ADDENDUM NO. 2

WASHINGTON STATE PARKS AND RECREATION COMMISSION KOPACHUCK STATE PARK DAY USE DEVELOPMENT SW-C1811

DATE: April 22, 2024

B **CABINET SECTION DETAIL**
 22 x 34 - 1" = 1'-0"
 11 x 17 - 1/2" = 1'-0"

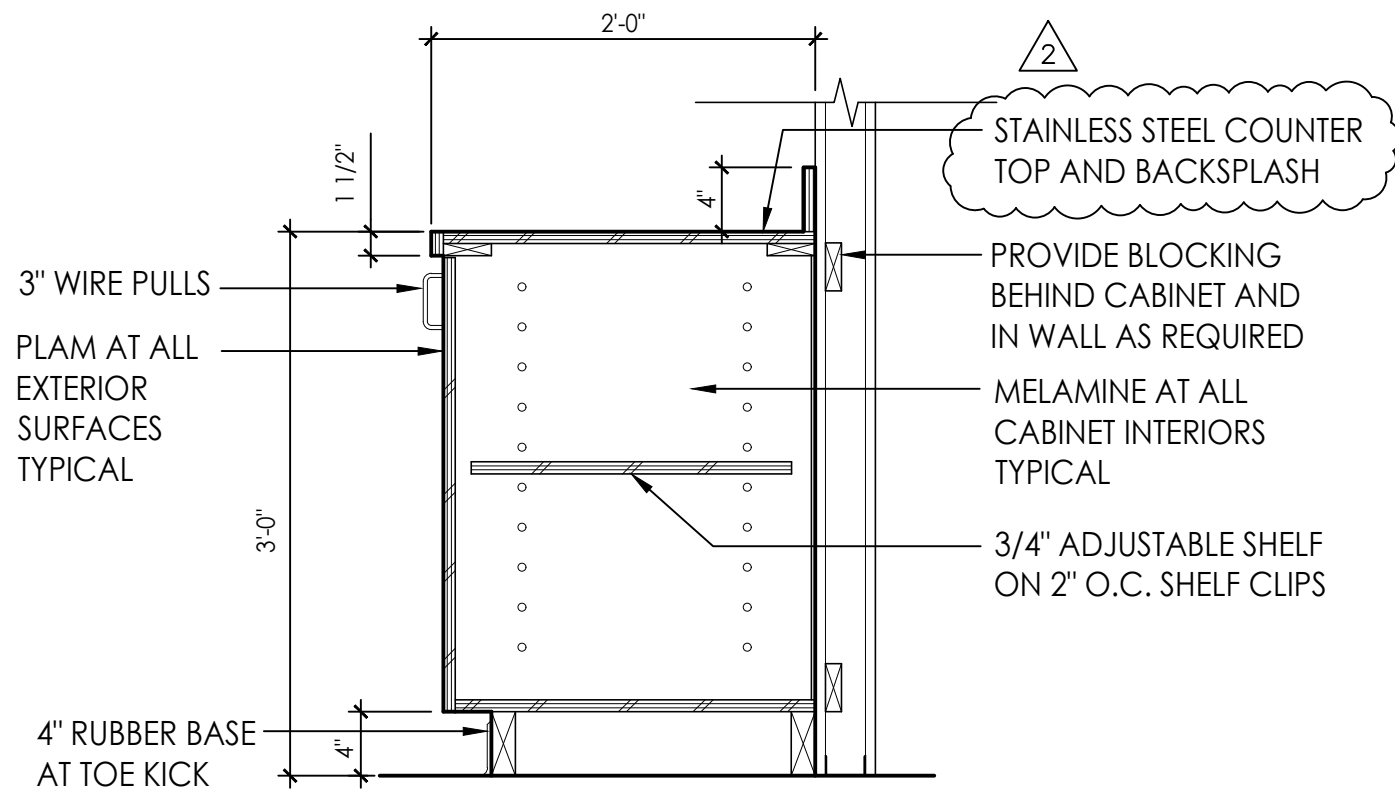
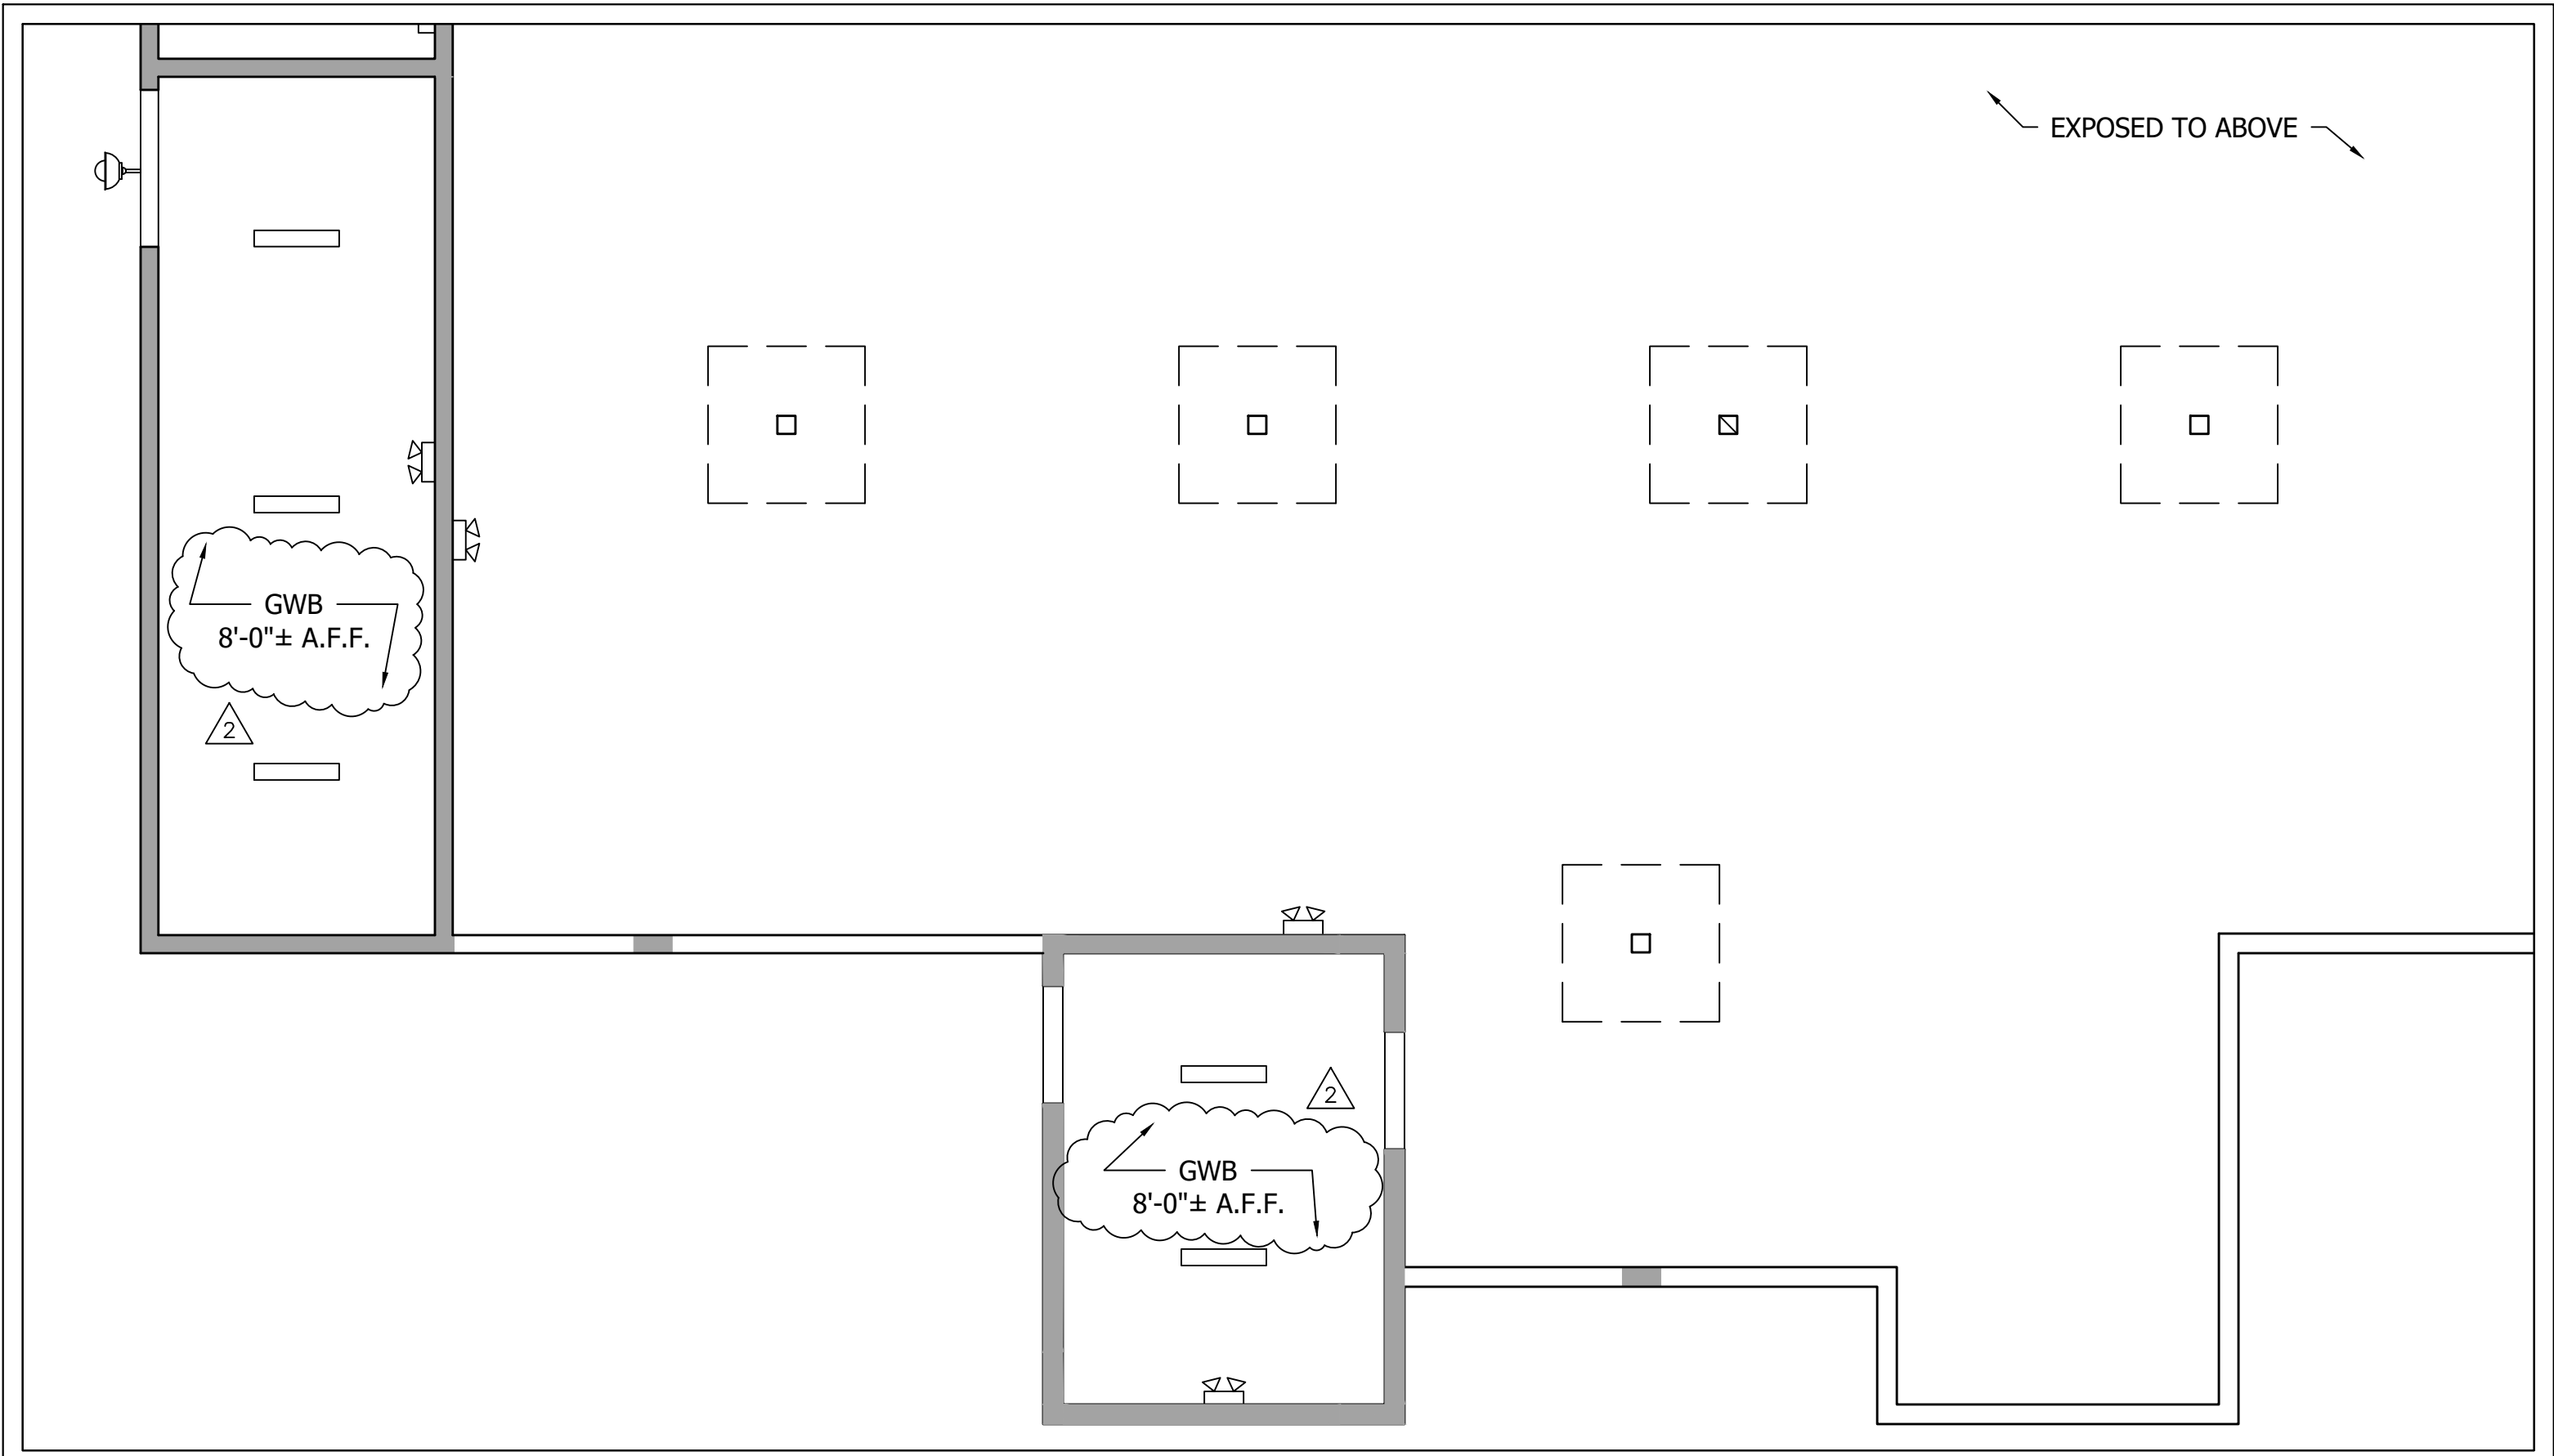
Sheet A5.2: **Revise:** Cabinet Section Detail ‘B’ and Sink Cabinet Detail ‘C’ as shown clouded on Addendum Sketch ADD-2.01 attached.

Day use building: we refer to Kitchen elevation 1/A5.2 and Section B/A5.2. Please confirm countertop and backsplash finish is stainless or plastic laminate?

Sheet A5.2, cabinet elevations call for stainless steel countertops, but the cabinet details call for Plam counters, please clarify.

Countertop and backsplashes in the kitchen are to be stainless steel per kitchen elevations 1/A5.2. Sections B/A5.2 and C/A5.2 incorrectly noted the countertop and backsplash material. See revised sections B/A5.2 and C/A5.2 as shown in Addendum Sketch ADD-2.01 attached.

Countertop and backsplashes in the kitchen are to be stainless steel per kitchen elevations 1/A5.2. Sections B/A5.2 and C/A5.2 incorrectly noted the countertop and backsplash material. See revised sections B/A5.2 and C/A5.2 as shown in Addendum Sketch ADD-2.01 attached.

DOOR TYPES

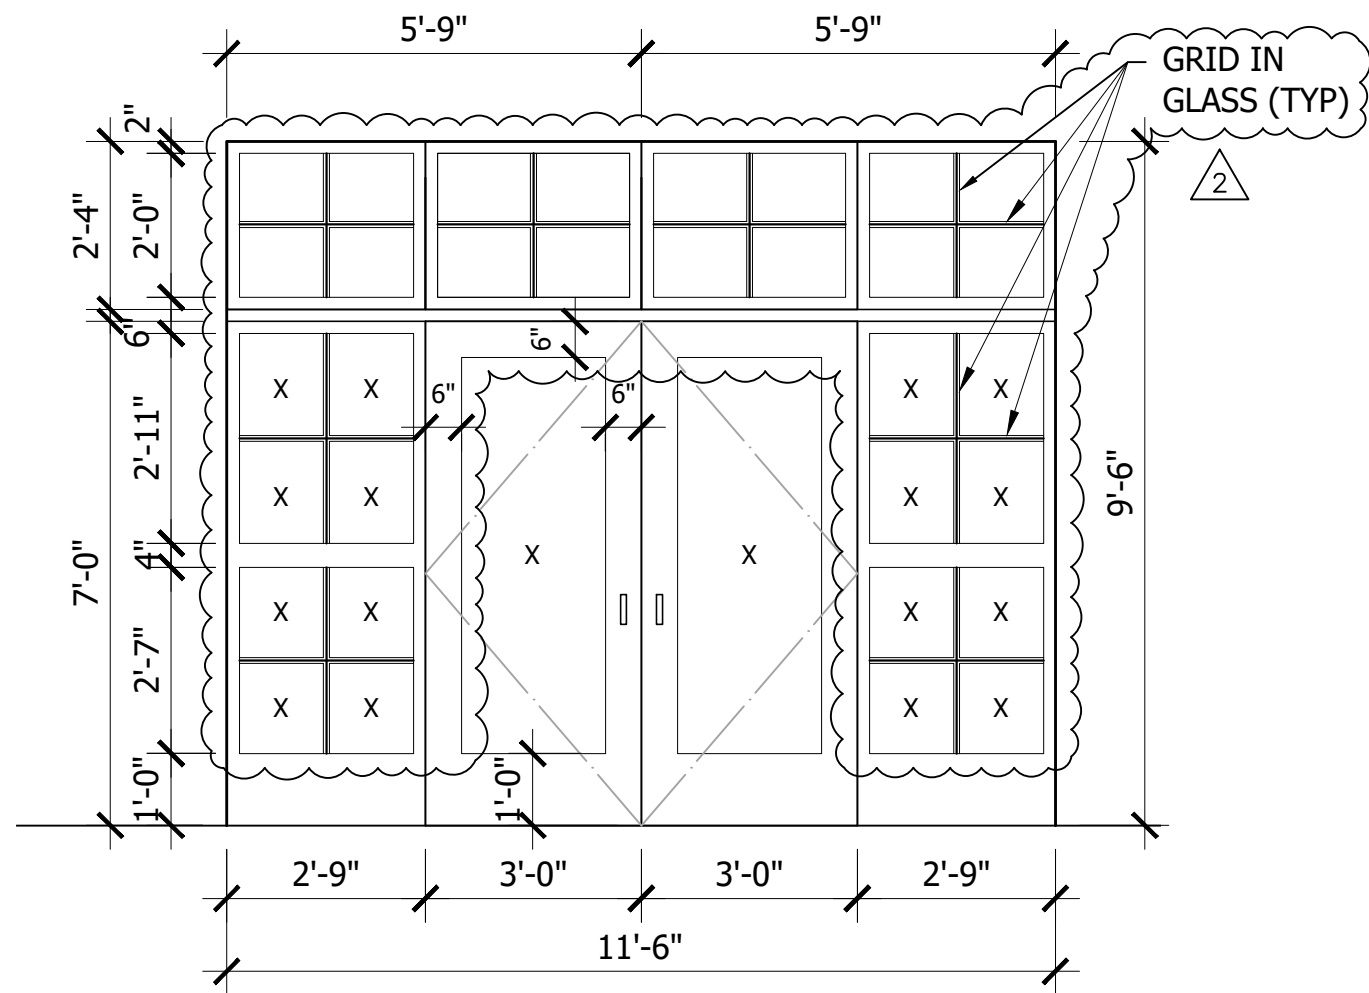
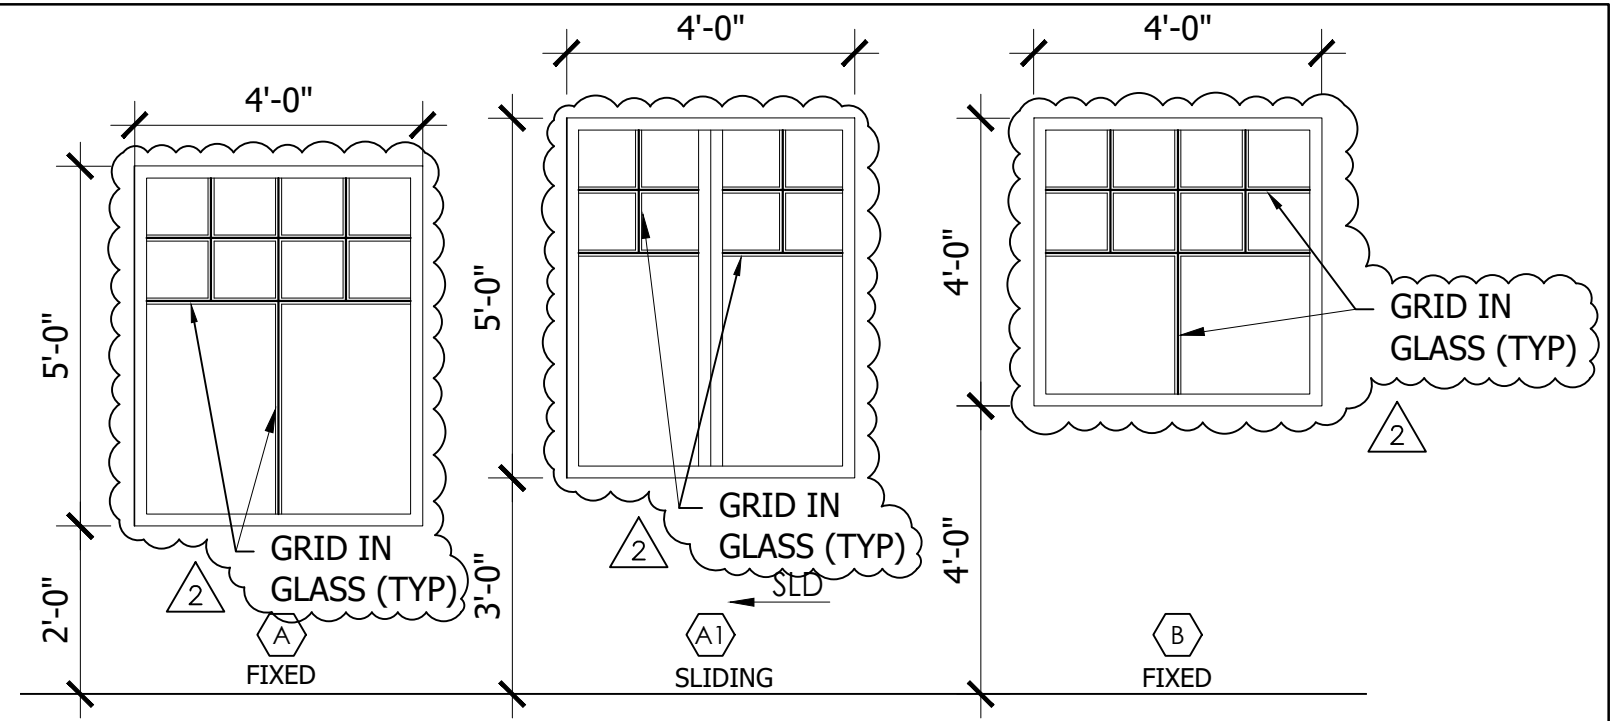
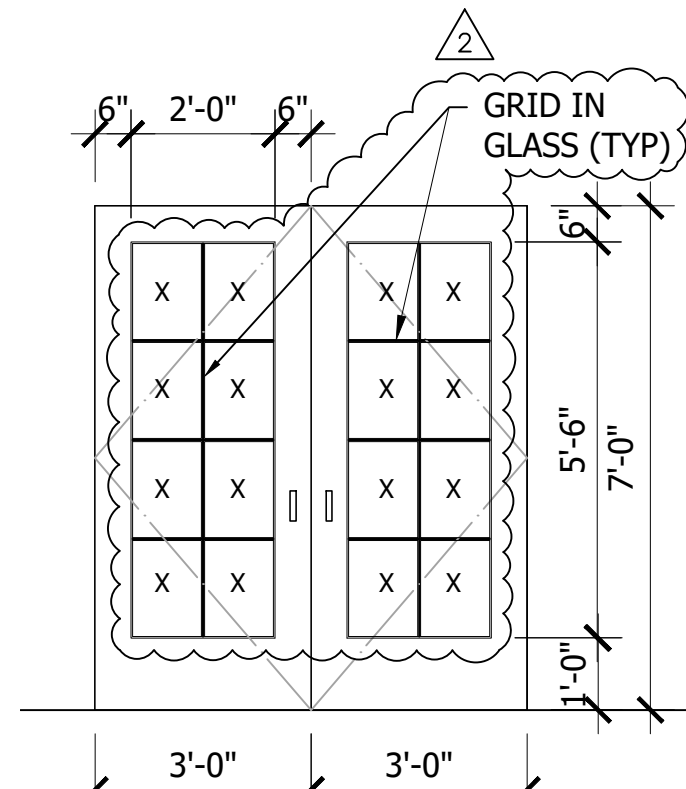
Sheet A5.0: **Revise:** Door Types and Window Types elevations as shown clouded on Addendum Sketch ADD-2.04 attached.

After reviewing Addendum #1, we have this question: On page 9 of the addendum, our submitted question is listed regarding ‘Aluminum Storefront Components vs. Grids in the Glass’. The response says to refer to A5.0 for clarification, but an updated drawing A5.0 was not included with Addendum #1 documents and A5.0 of original bid drawings does not specify anything regarding grids. We would like clarification so we can include accurate design intent in our proposal, specifically at the storefront entry of the day use building. Please provide an updated A5.0.

In the contractor’s original question, they referenced Elevation A on sheet A3.0 as not having enough detail for the glazing frames/muntin. Referencing sheet A5.0 was provided in the Addendum #1 response as it has more detail. For additional clarification, see revisions to the Door and Window Types details on sheet A5.0 as shown on Addendum Sketch ADD-2.04 attached.

DWG NO/SHEET: 1 of 1 / C3.13
 DRAWING TITLE:
 LAYOUT & MATLS. PLAN
 WELCOME CENTER AREA

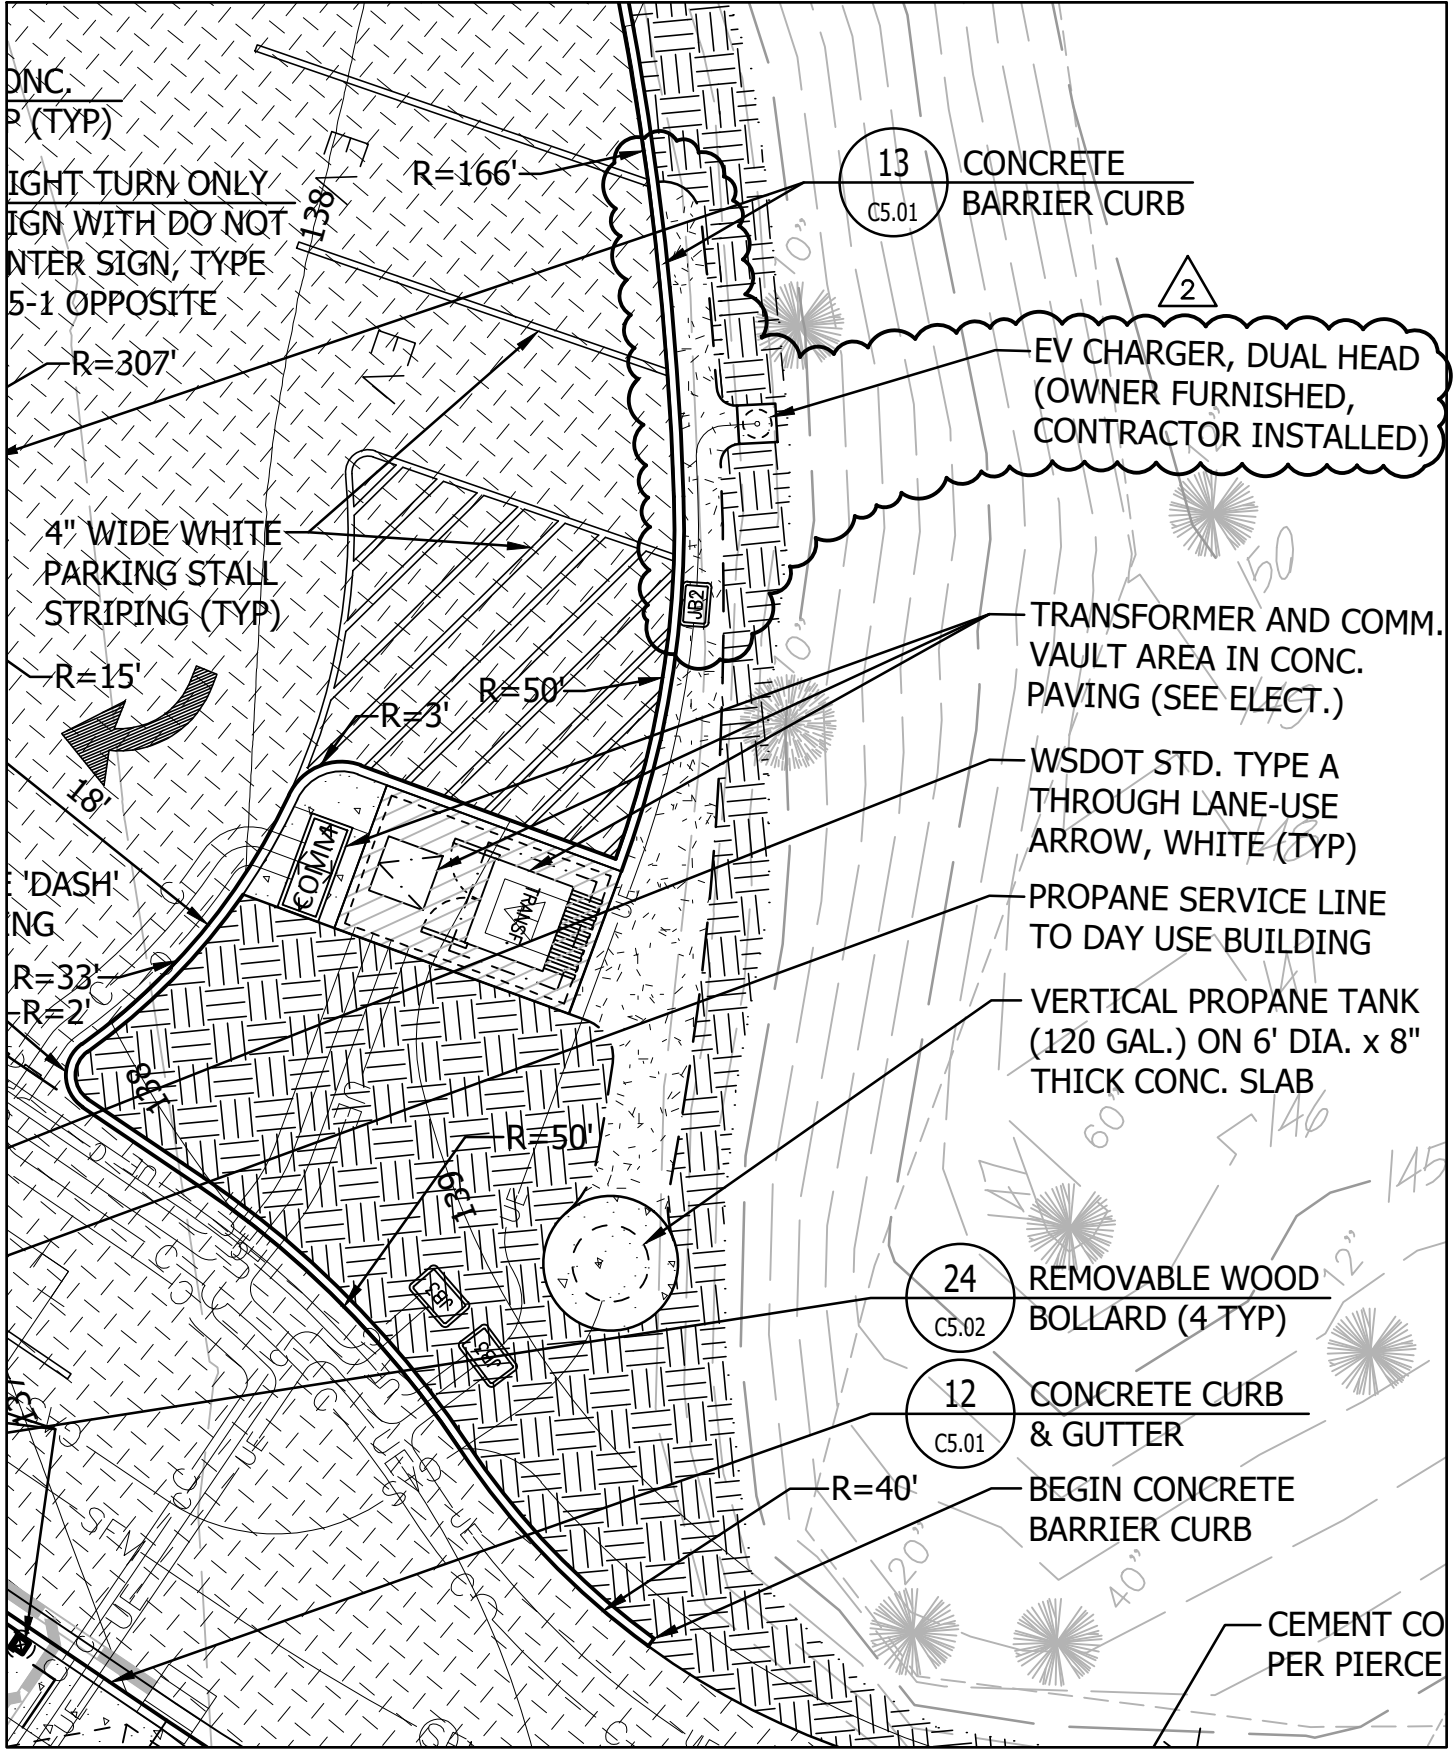
Sheet C3.13: **Revise:** EV Charger quantity and location as shown clouded on Addendum Sketch ADD-2.05 attached.

EV CHARGER, DUAL HEAD
 (OWNER FURNISHED,
 CONTRACTOR INSTALLED)
